APPROVED WITH CONDITIONS

Plug And Abandonment Procedure

Cato San Andres #586

Chaves County, NM / API 30-005-29025

Proposed Wellbore Diagram

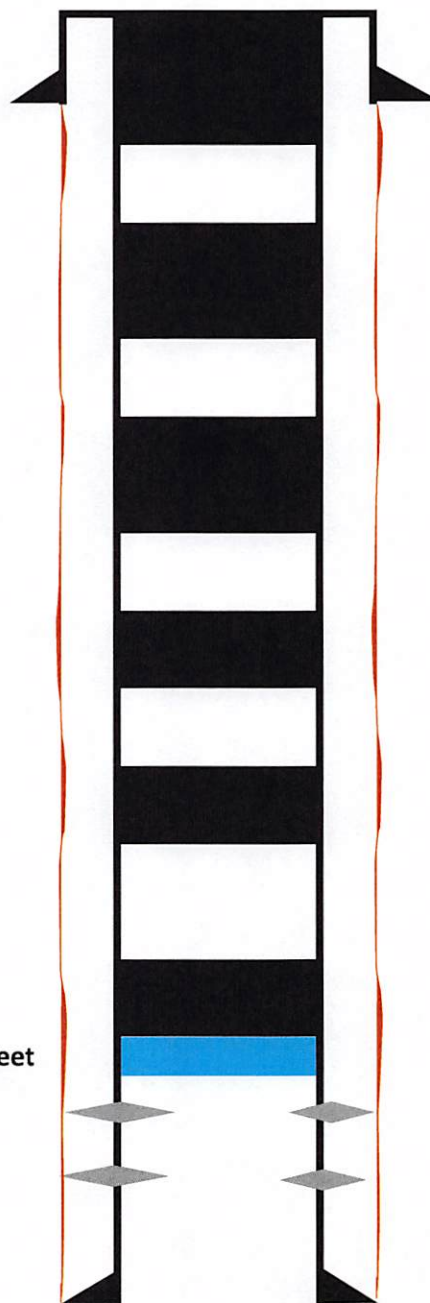
Perf & Sqz all shoes.

Perf & Sqz all plugs with no cmt behind pipe.

Adhere to NMOCD COAs attached.
